CITY OF FRANKLIN
PLAN COMMISSION MEETING*
FRANKLIN CITY HALL COUNCIL CHAMBERS
9229 W. LOOMIS ROAD, FRANKLIN, WISCONSIN
AGENDA
THURSDAY, OCTOBER 5, 2017, 7:00 P.M.

**CITY OF FRANKLIN****REPORT TO THE PLAN COMMISSION****Meeting of October 5, 2017****Special Use**

Project Name:	O'Reilly Auto Parts Special Use
Project Address:	7251 South 27 th Street
Applicant:	Patrick Blee, Architect, PLLC
Property Owner:	O'Reilly Automotive Stores, Inc.
Current Zoning:	B-4 South 27 th Street Mixed Use Commercial District
2025 Comprehensive Plan	Mixed Use
Use of Surrounding Properties:	St. James Catholic Congregation and School to the north, Park Motel and Little Cancun restaurant to the south, City of Oak Creek (residential) to the east and single-family residential to the west
Applicant Action Requested:	Recommendation of approval for the proposed Special Use and associated Site Plan for the development of an O'Reilly Auto Parts store.

1 MASONRY SCREEN FENCE REFUSE ENCLOSURE PLAN
C2.3 SCALE: 3/4" = 1'-0"

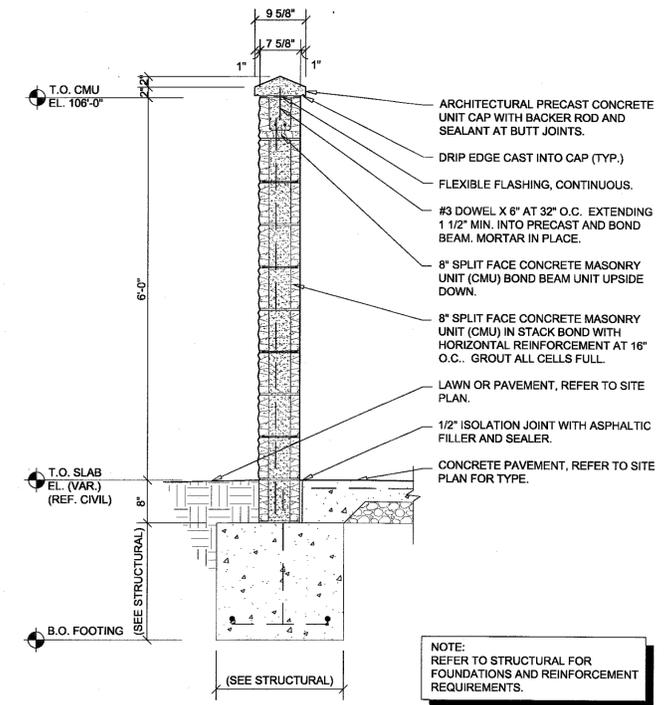
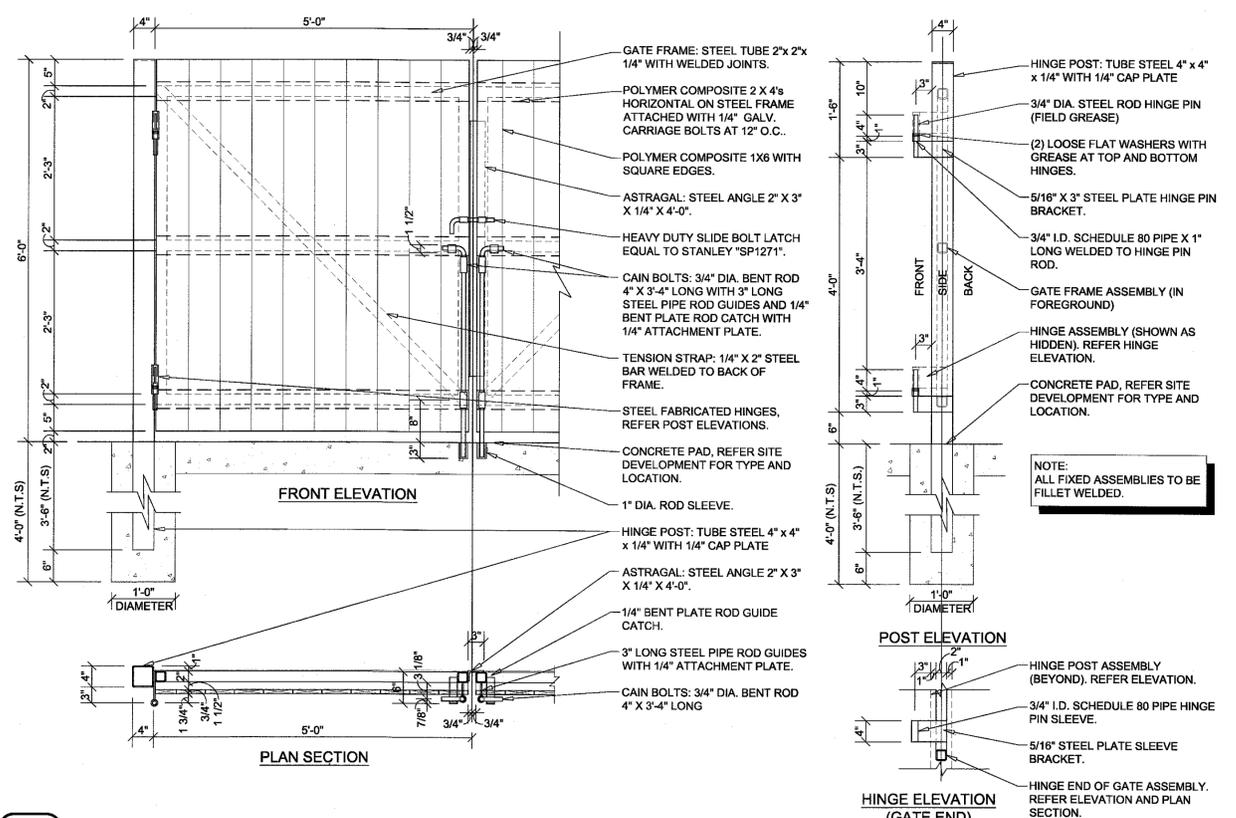
8. Please provide dumpster enclosure details. Staff assumes this may be on Sheet C2.2 or C2.3; however, those plan sheets were not provided. Staff recommends that the dumpster enclosure materials match that of the principal building. *See enclosed sheet C2.3.*
9. On Sheet C2.1, please include additional site data, such as square footage of proposed impervious surface, greenspace and Landscape Surface Ratio (see definitions below). *See enclosed sheet C2.1.*

1 LANDSCAPE PLAN
L1.1 SCALE: 1" = 20'-0"

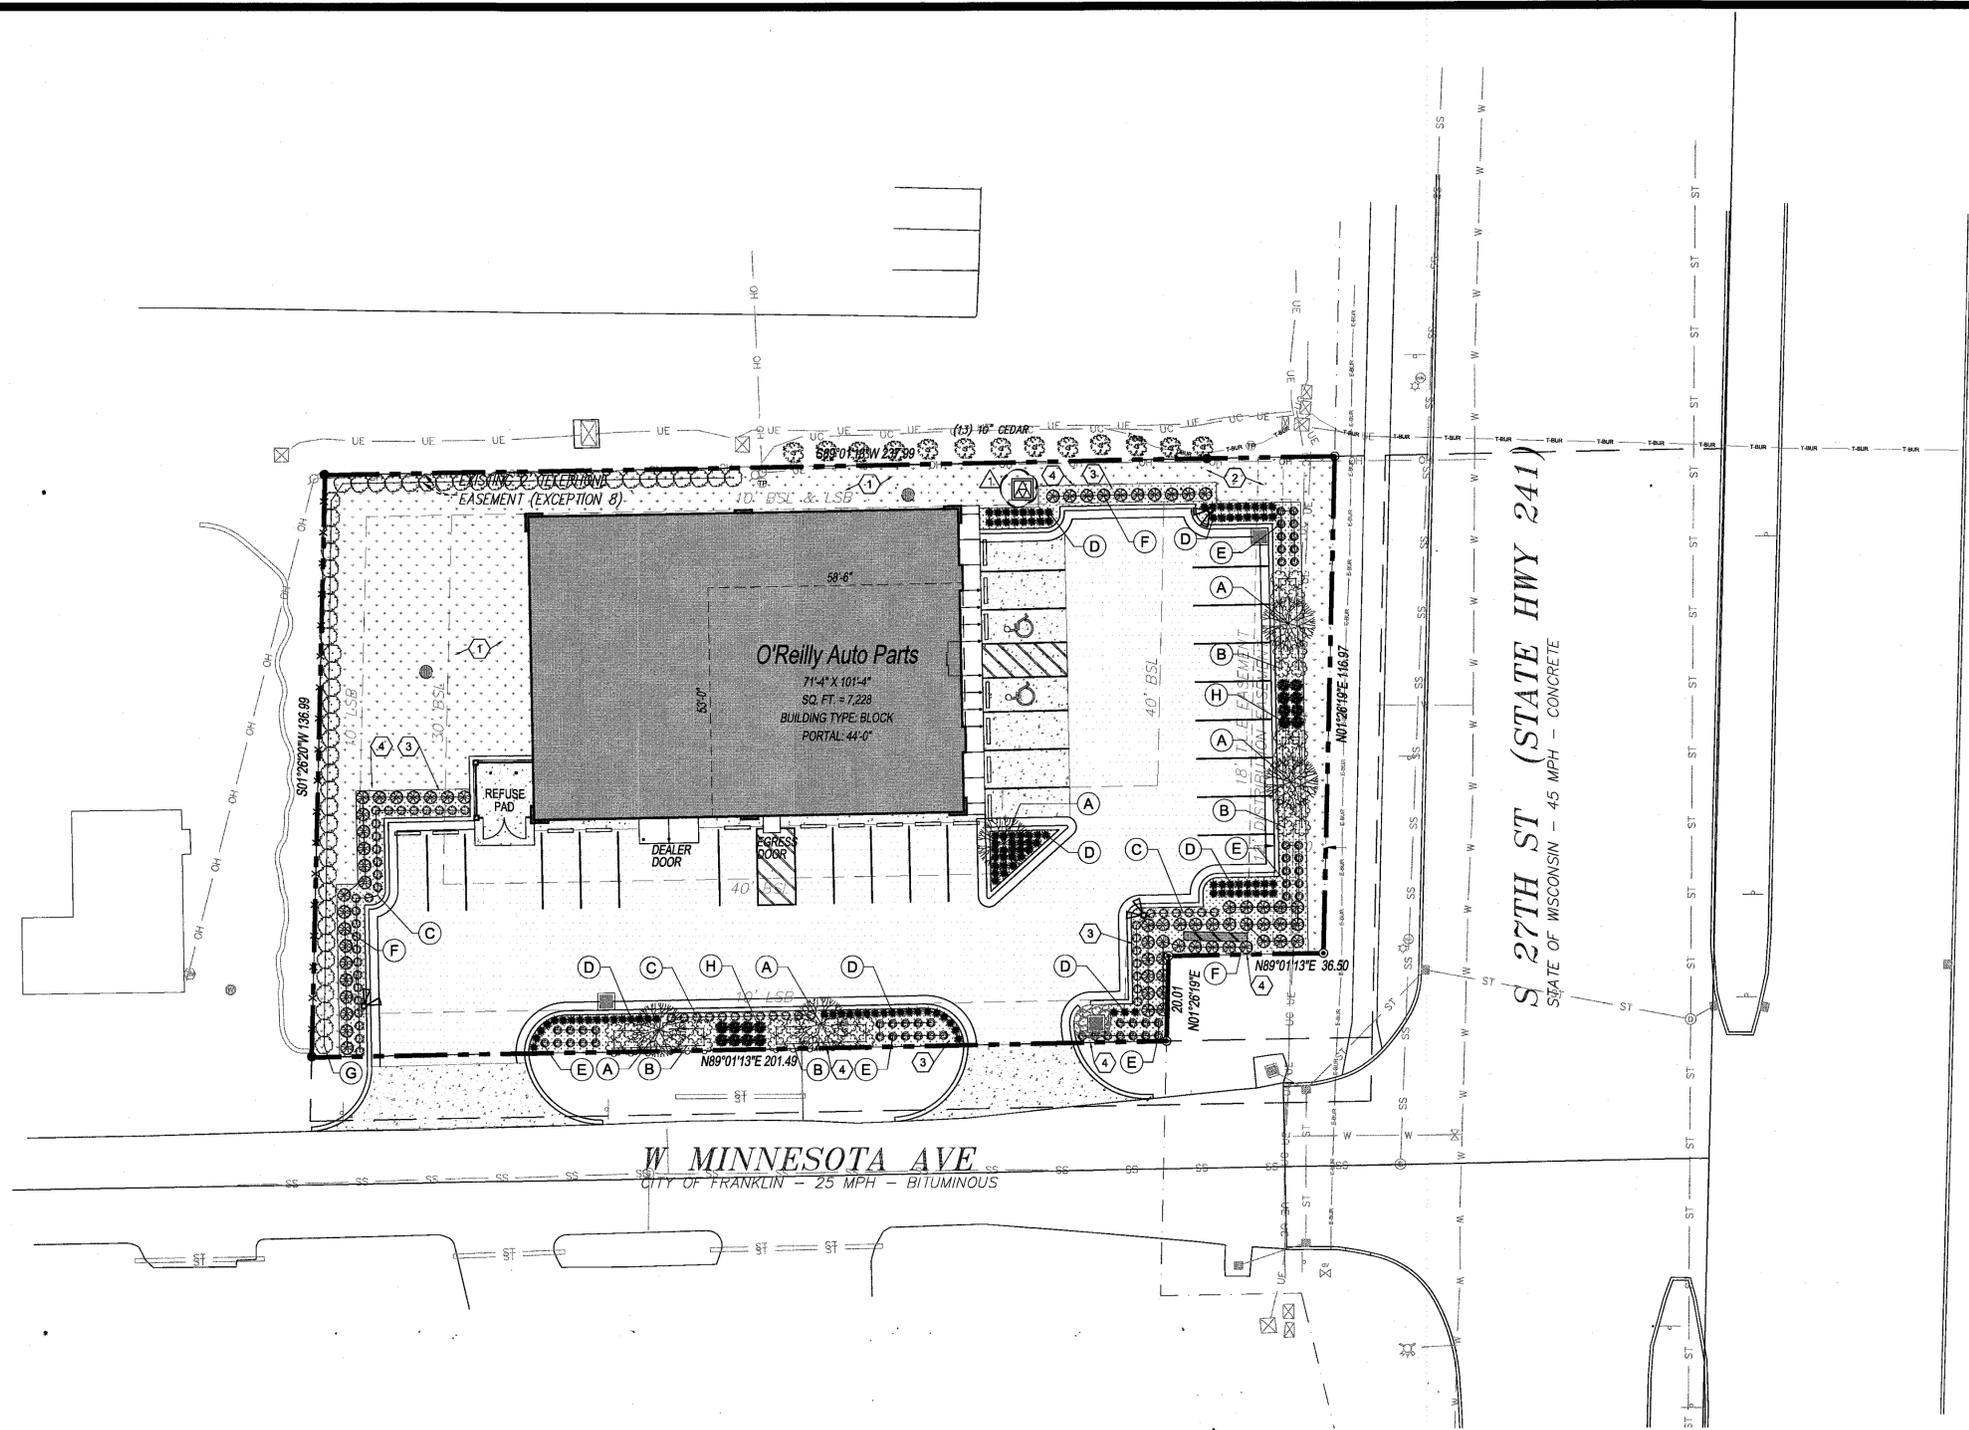
Staff recommends that the applicant shall submit a Landscape Plan, for review and approval by Department of City Development staff, that includes the following revisions, prior to issuance of a Building Permit:

- A greater variety of plantings shall be provided along the west and north property line to serve as the bufferyard, opposed to consisting of entirely Emerald Green Arborvitaes. Furthermore, the plantings shall be staggered, opposed to in a single row.

- Planting size shall be indicated in the Planting Schedule and comply with minimum sizes within Table 15-5.0302 of the UDO.
- A planting guaranty of 2-years shall be provided by the landscape contractor and that guarantee noted on the Landscape Plan per Section 15-5.0303G.3. of the UDO prior to issuance of an Occupancy Permit.

11. Please organize the plantings within the Planting Schedule by plant type (i.e. Canopy/Shade Trees, Evergreens, Decorative Trees and Shrubs). *See enclosed L1.1.*

12. Please include the landscaping calculations on the Landscape Plan (i.e. how many plantings are required per the UDO, including the 20% increase for the bufferyard). Note that the UDO requires rounding up to the nearest whole number. Staff recommends exceeding landscape requirements as part of the compensation for the requested waivers from the South 27th Street Design Overlay District standards. *See enclosed L1.1.*

13. Please indicate the planting size in the Planting Schedule, opposed to the reference provided. Note that evergreens and arborvitae within the bufferyard must have a planting height of 6-feet. *See enclosed L1.1.*
